THE STORE
854 HUNTER STREET, NEWCASTLE

Building Envelopes Setbacks

Scale	1:125 @ A1	1:250 @ A3
Drawn	MT	Checked BD
Project no.	S12133	
Status	Development Application	
Plot Date	12/04/2022 2:08:53 PM	
BIM	RESIDENTIAL ARCH	
Drawing no.	A01.MP.100	Revision 2

**854 Hunter Street
 Newcastle**
 Section
 North/South section through West Tower & Podium

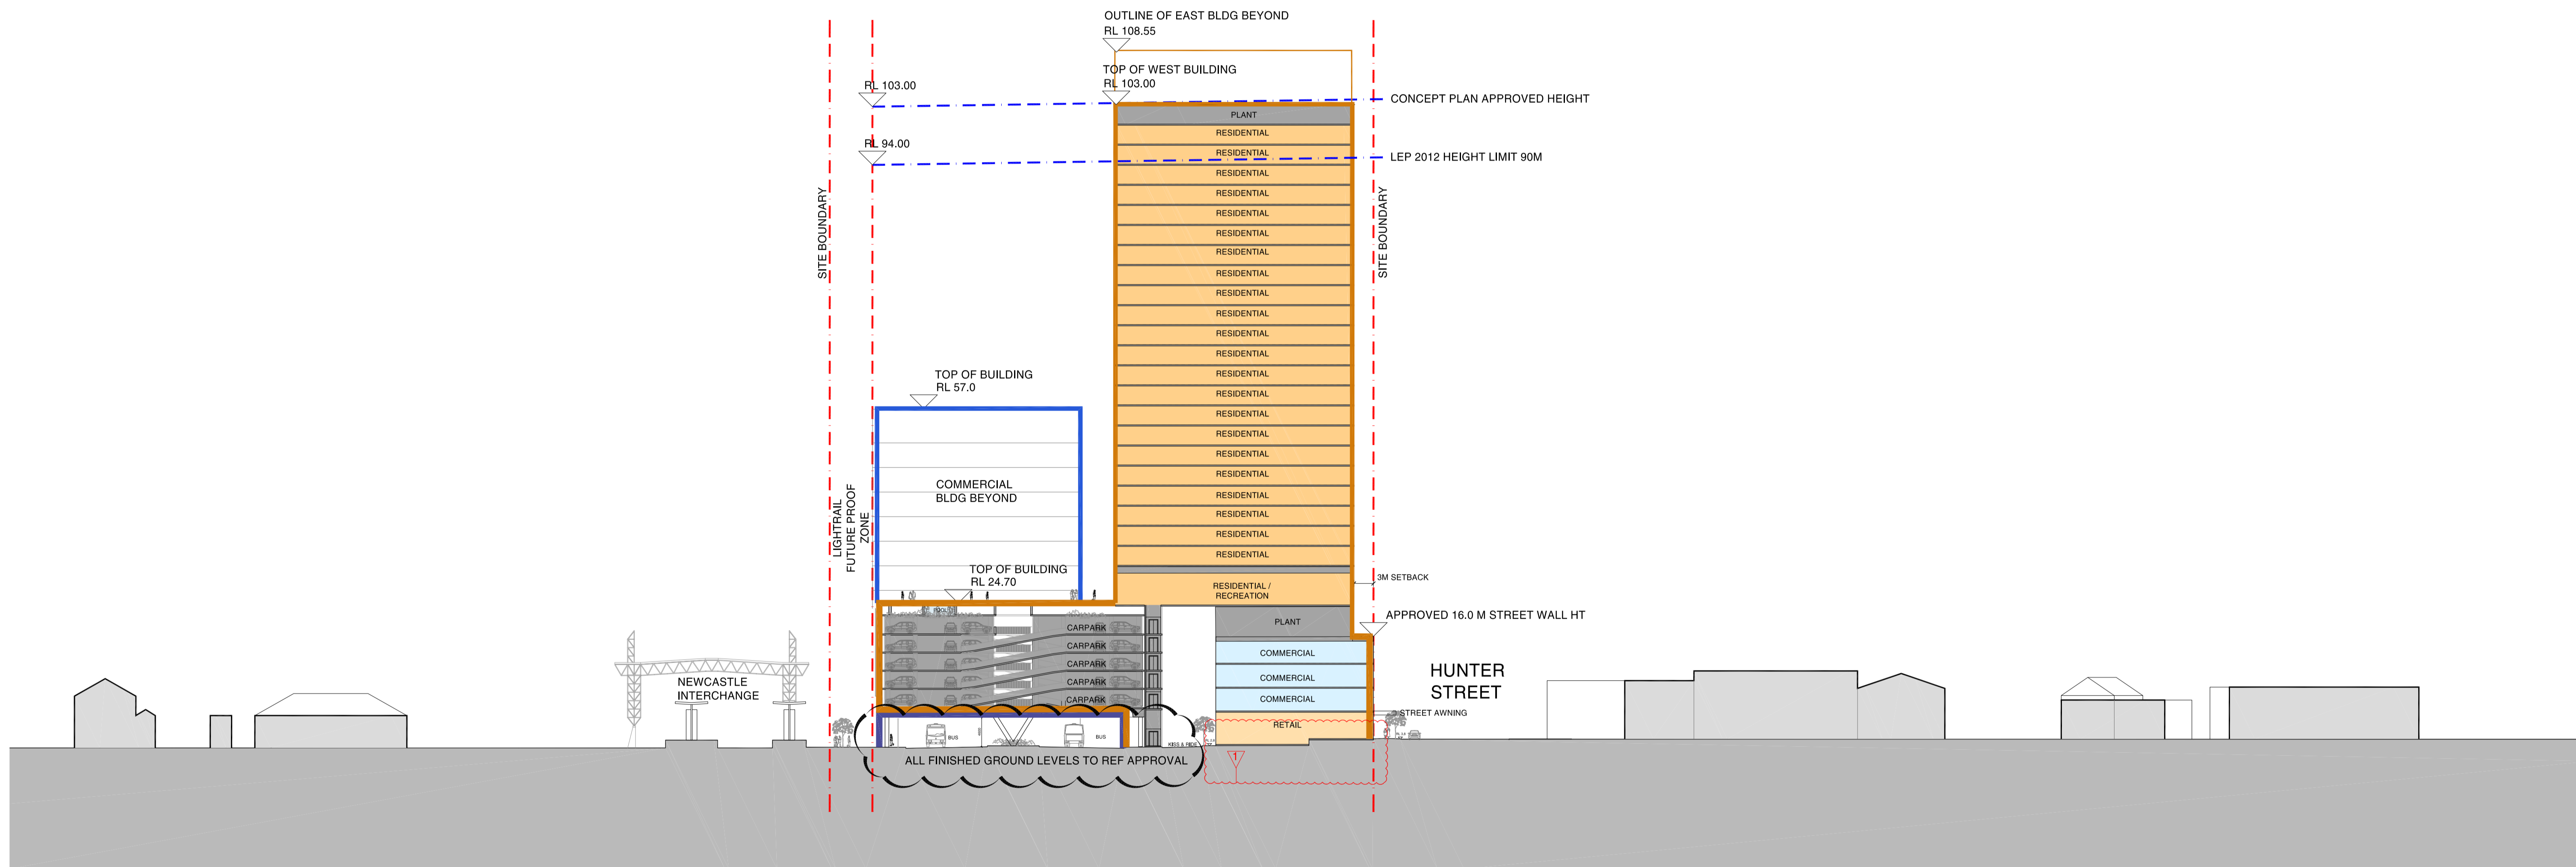
MODIFICATIONS:
 1 - UPDATED PODIUM EXTENTS - REMOVED BASEMENT

**854 Hunter Street
Newcastle**
 East-West Indicative Section
 Hunter St

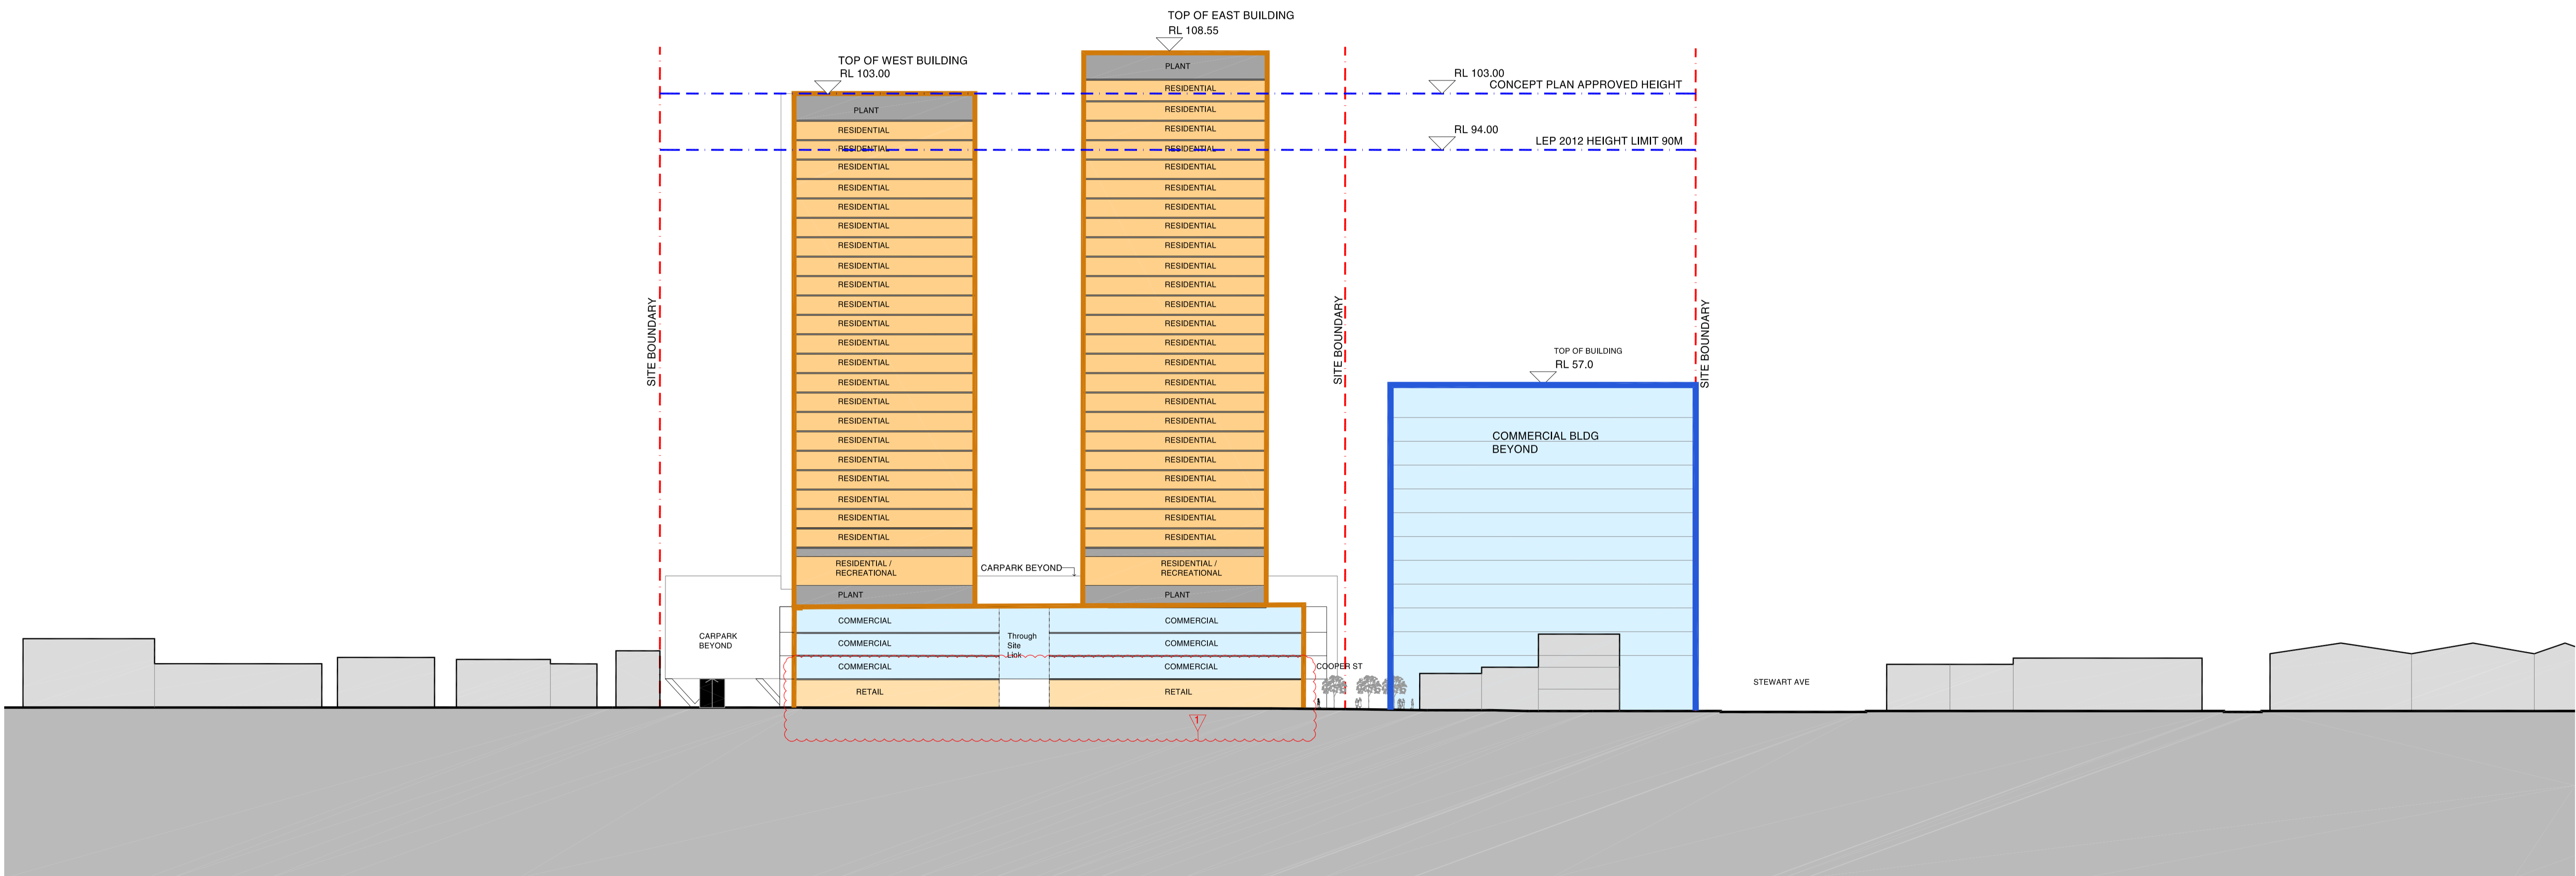
MODIFICATIONS:
 1 - UPDATED PODIUM THROUGH SITE LINK EXTENTS AND REMOVED BASEMENT
